TECHNICAL NOTE TN-1242b-SR

5030, 5035, 5040 Firmware Upgrade to 4.33 & TOP-TPA Upgrade to 4.13.00

19 December 2006 (Updated 12 February 2007)

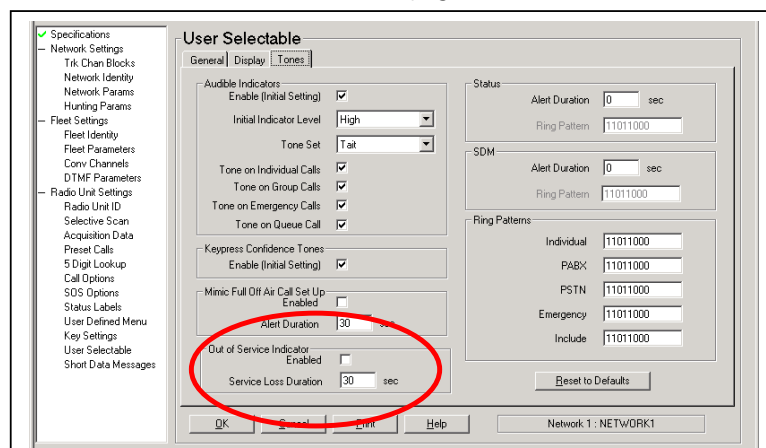
- An audible loss of MPT trunked service indicator has been added. This is enabled on the 'User Selectable' page, on the 'Tones' tab.

The 'Enabled' tick box will enable the out-of-service audible indicator function.

The 'Service Loss Duration' sets the period between the audible indicator announcements once MPT trunked service is lost. This can be set from 10 to 180 seconds between announcements, with the default being 30 seconds. (Raised as TIMS 53687).
